# STAFF RECOMMENDATION

NCPC File No. 6383

**GEORGETOWN WATERFRONT PARK**  
REVISED LANDSCAPE DESIGN FOR THREE OVERLOOK LOCATIONS  
3000 K Street, NW  
Washington, DC

September 29, 2005

**MODEL VIEWS OF  
OVERLOOK AREA NO. 1**

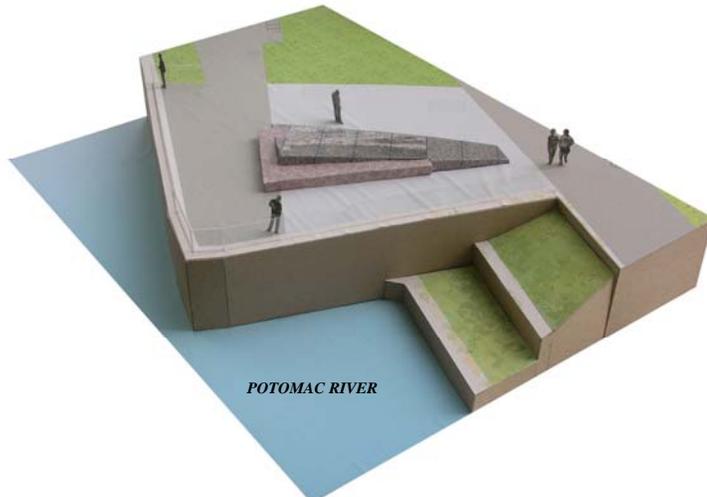
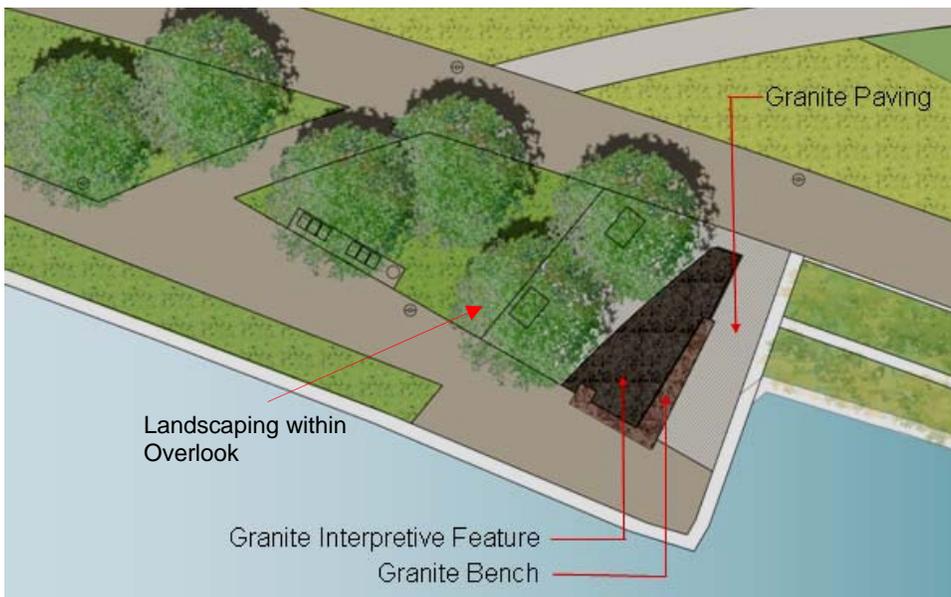
The Commission, at its meeting of September 15, 2005, approved the revised design of the three overlook areas in the park, but requested further details on the pedestrian pavement area material finishes and better information on the elements involving the graphic backdrops.

Some of the concerns expressed by CFA Commissioners about the overlook features primarily focused on the height of the graphic areas, the potential misuse of the slanted block areas for skateboarding or sitting, and the interpretive information to be presented at those locations.

- **Approves** the preliminary site development plans for the Georgetown Waterfront Park Revised Landscape Design for Three Overlook Locations, as shown on the NCPC Map File No. 72.00(70.00)-41686,
- **Requests** in the submission of the overlook area final site development plans that seating and backdrop material samples, exact structuring layout, and complete description and details of landscaping, pavement, and graphic artwork information are provided to the Commission.
